A REPAIR

### ON-SITE SEWAGE DISPOSAL SYSTEM HOWARD COUNTY HEALTH DEPARTMENT BUREAU OF ENVIRONMENTAL HEALTH

SUBDIVISION: Benson LOT NUMBER: 2

ADDRESS: 3506 Lakeway Drive PROPERTY OWNER: \_\_\_\_\_

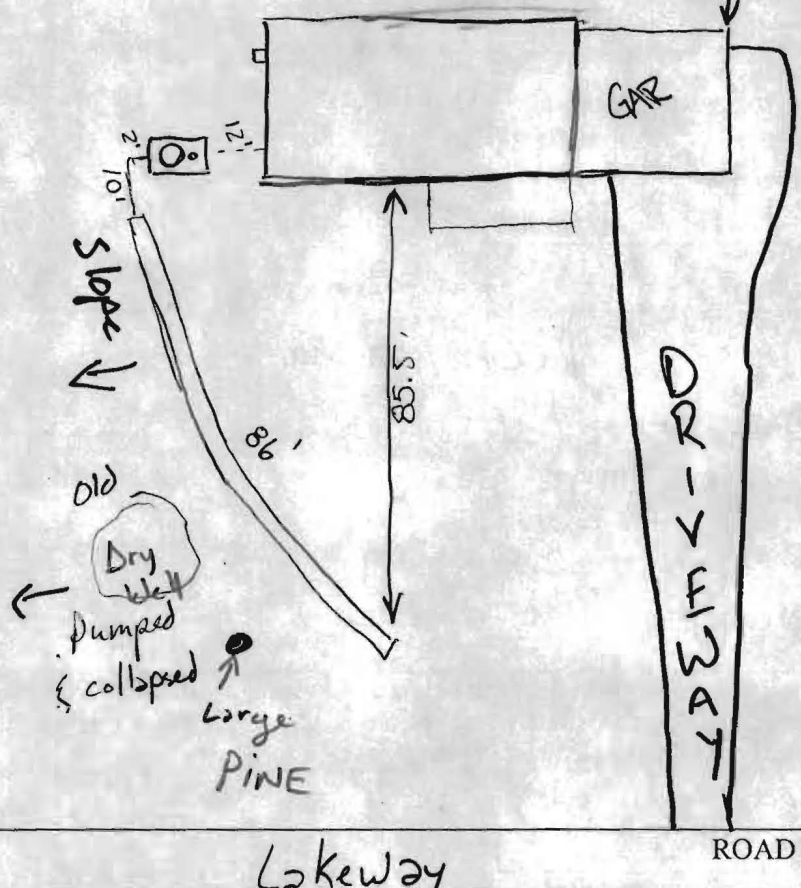
PRE-CONSTRUCTION 5/8/06 Install one trench close to contour above Drywell to get gravity. Trench will be slightly deeper as it gets further from House. **GAC**

INSTALLATION 5/10/06 - Trench installed & ok to cover. **GAC**
